## CITY of NOVI CITY COUNCIL

**Agenda Item 5**  
**May 23, 2016**

**SUBJECT:** Consideration of the request of The Ivanhoe Companies for Beacon Hill, JSP 15-08, with Zoning Map Amendment 18.710, to rezone property in Section 12, located on the northeast corner of Twelve Mile Road and Meadowbrook Road from RA (Residential Acreage) to R-4 (One-Family Residential) and B-3 (General Business), with a Planned Rezoning Overlay (PRO), and to approve corresponding Concept Plan. The subject property is approximately 21.13 acres. The applicant is proposing a 42-unit single-family residential development with frontage on and access to Meadowbrook Road, up to 22,000 square feet of commercial space with frontage and two access drives on Twelve Mile Road, and an open space/park area at the corner of the intersection.

**CONCEPT PLAN**

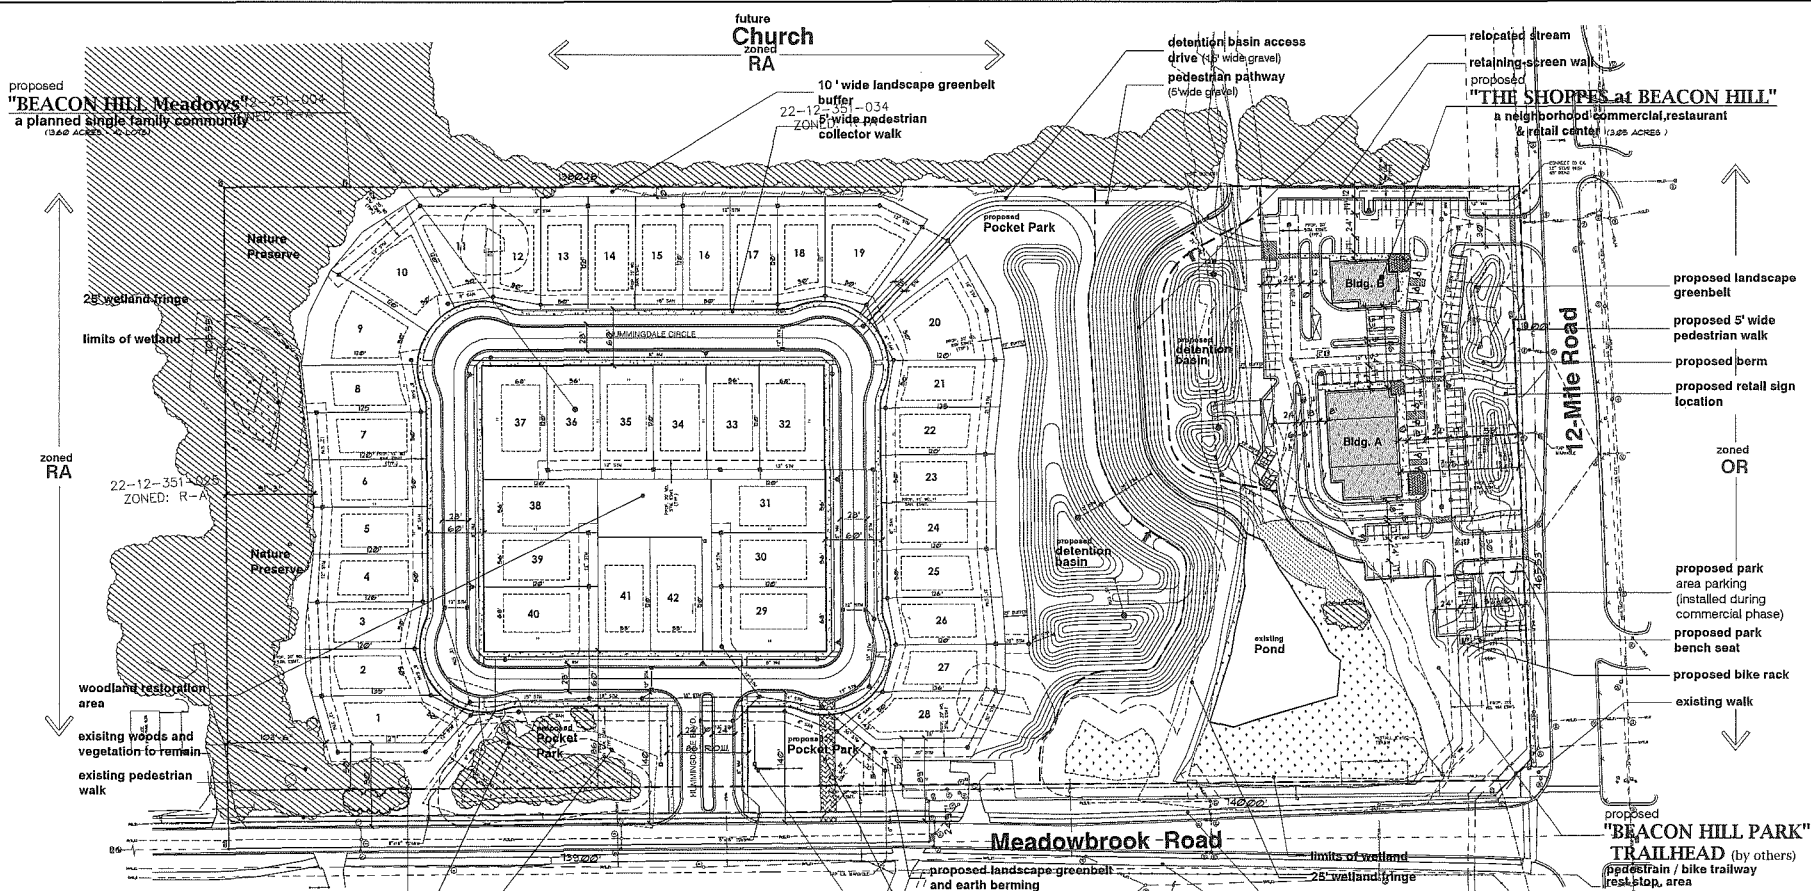
The applicant has proposed a 42-unit single-family development with one boulevard entrance drive on Meadowbrook Road, and a maximum of 22,000 square foot commercial space in two buildings fronting on Twelve Mile Road. The plan also shows the applicant's offer to dedicate to the City a 3.28 acre park with a trailhead that extends from the southwest corner of the site, easterly across the property along the stream.

The plan proposes to restore the degraded function of both the wetland and the stream located on the south end of the site. Restoration activities include abandonment of the existing 350 foot stream channel, and construction of a relocated stream channel of approximately 480 feet, using a natural channel design. The applicant proposes to improve plant species diversity within the existing open water and emergent wetland by removing the invasive plants, and replanting with native species, including wildflowers and trees. The natural features setback areas will also be restored. Both an MDEQ wetland Permit and a City of Novi Wetland Use Permit will be required for the proposed impacts.

The site contains regulated woodlands: the submitted woodland plan shows a total of 402 regulated trees are proposed to be removed from the site, and all of the required 718 replacement credits are proposed to be planted on the site. Both the City's Landscape Architect and Environmental Consultant support the alternative streetscape landscaping along Meadowbrook Road that the applicant has developed through coordinated work with the Tollgate Education Center. ECT supports the use of Woodland Replacement Trees and shrubs, as currently proposed, in order to supplement the required trees along Meadowbrook Road, but does not support the replacement of the required street trees with Woodland Replacement trees.
